1. Response to editor

REVIEW of the paper “Improving Runoff Simulation in the Western United States with Noah-MP and VIC” by Lu Su et al.

Figure 1 (a) framework of the calibration and regionalization processes adopted in this study. (b) model simulation inputs and output.

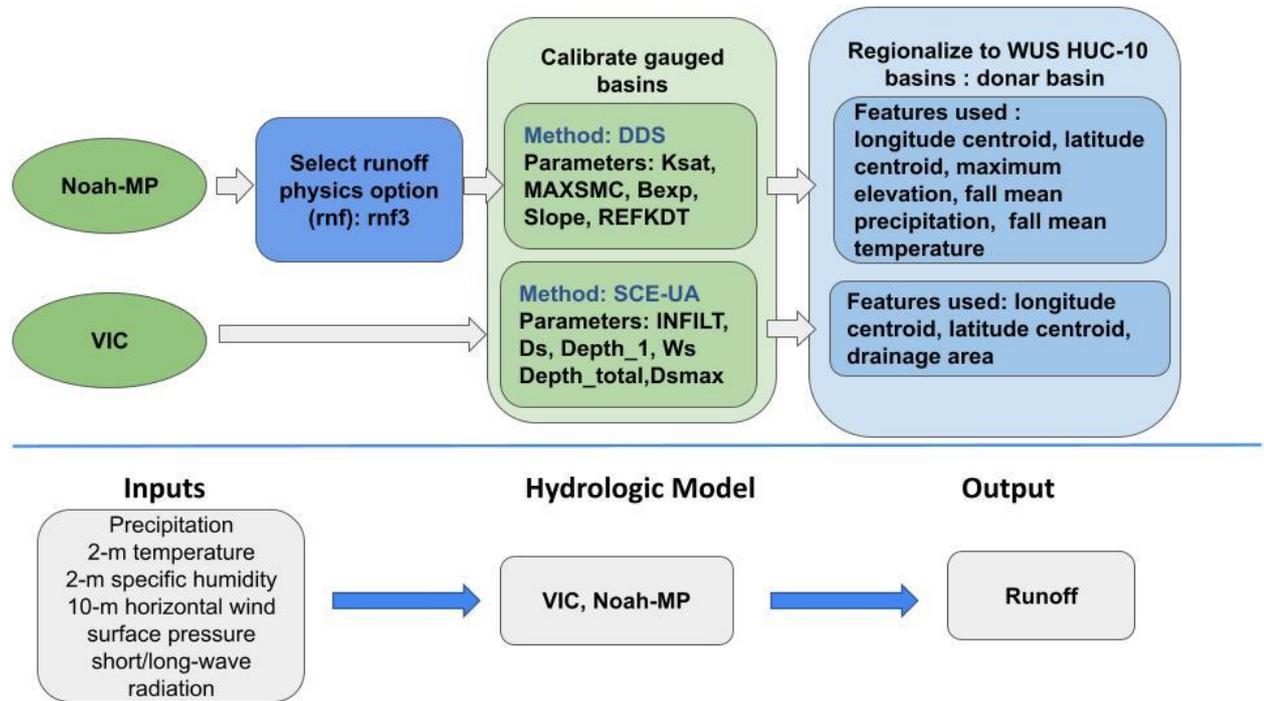
[Please a conceptual diagram/framework describing your methodology.](#)

Thanks for the suggestion; we now include such a diagram in Figure 1 in our revised manuscript (reproduced below). This diagram illustrates our calibration

framework, delineating the distinct but complementary approaches we took for each model.
